Re: Application for Meridian
Oil Co. Lined Evaporation
Ponds to be located in
Section 23, Township 30
North, Range 7 West,
Rio Arriba County, NM

Re: Meridian Oil Company Evaporation Pond Application

Re: Meridian Oil Co.
Evaporation Ponds

We have reviewed your application for approval to install three lined evaporation ponds in Section 23, Township 30 North, Range 7 West, Rio Arriba County, New Mexico. Upon review of the blueprints, we have the following questions and comments:

PRELIMINARY DESIGN					
1 AC EVAPORATION POND					
FOR MERIDIAN OIL					
SCALE	DATE	REVISED	DRAFTED BY	SHEET	OF
1"=50'	NOV 14 85		PETERSON	1	
PROJECT NO.		CHECKED BY			
41355					
SAN JUAN ENGINEERING, INC.					
2101 SAN JUAN BLVD. FARMINGTON, N.M. 87401

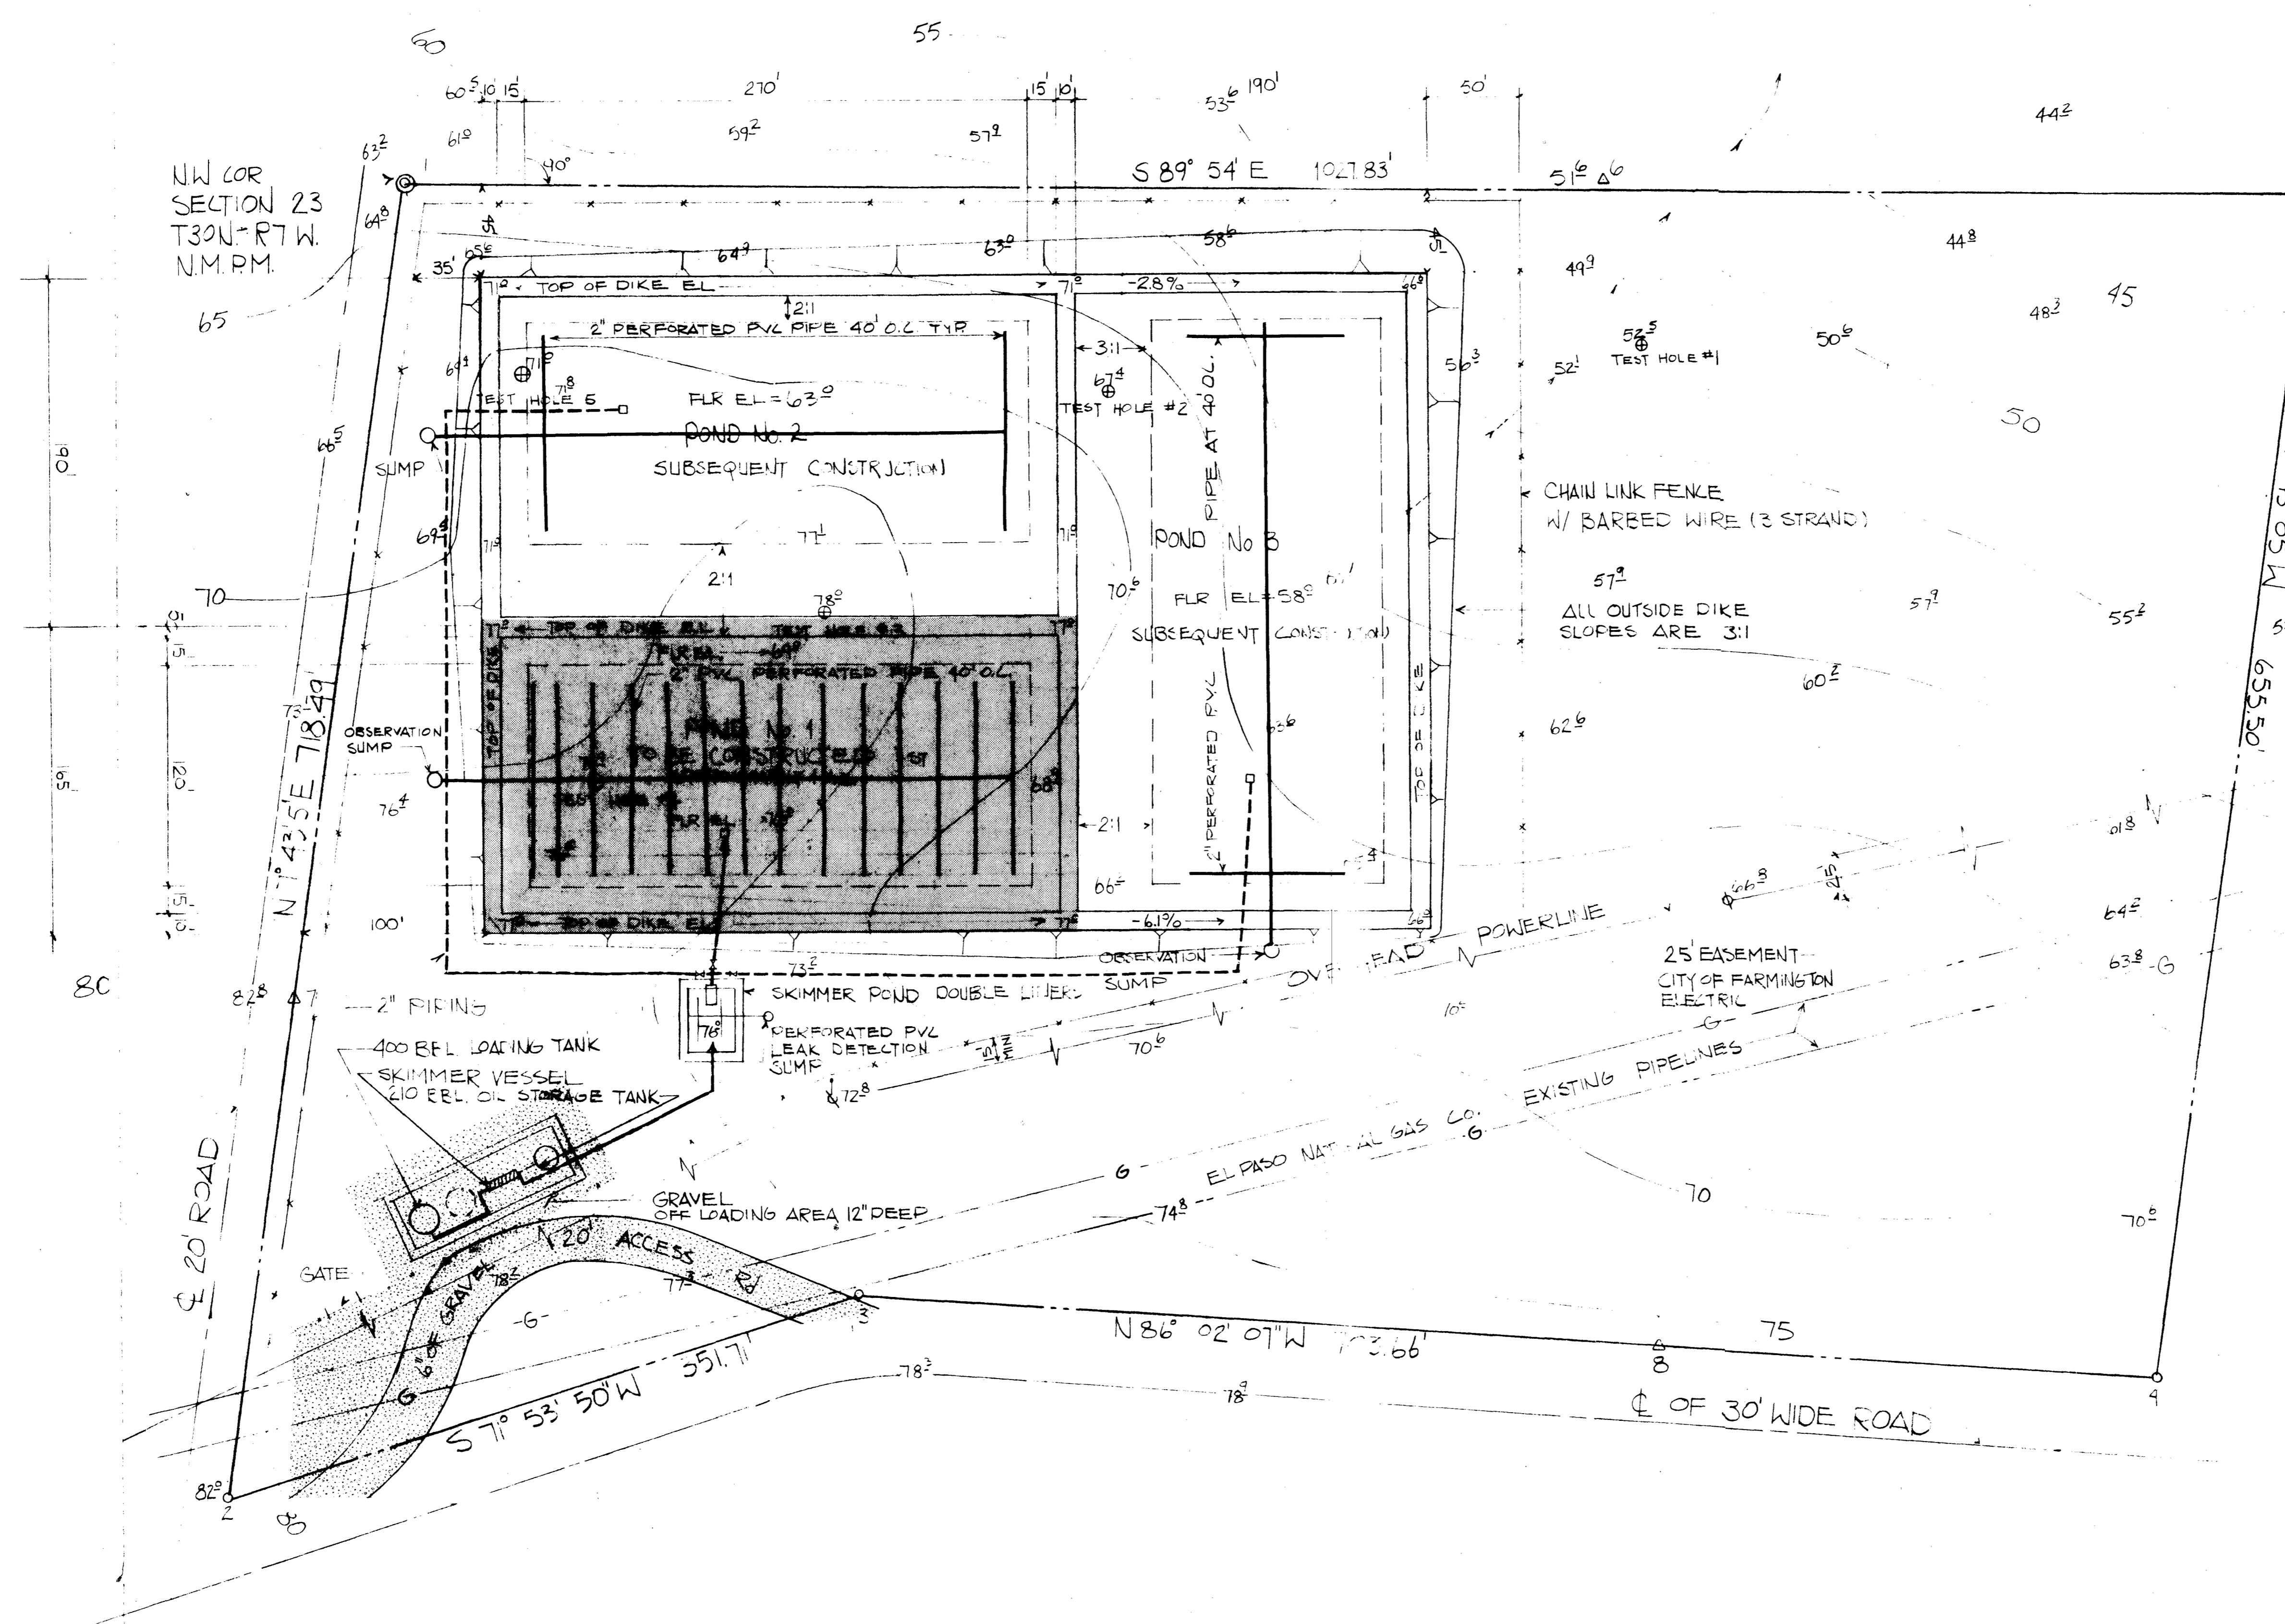
I have received the preliminary drawings for the Meridian Oil proposed evaporation pit to be located in the NW/4 NW/4 of Section 23, Township 30 North, Range 7 West, Rio Arriba County, New Mexico. I understand that these are preliminary drawings and that much information has been omitted that will necessarily be included in the final design drawings.

I noticed on the drawings (Note #4) that all construction is to comply with New Mexico OCD Order No. R-3221-C. In order to facilitate the approval process for this pit, I have enclosed three sets of guidelines that will be helpful to you for this pit approval and for any future pits you may engineer.
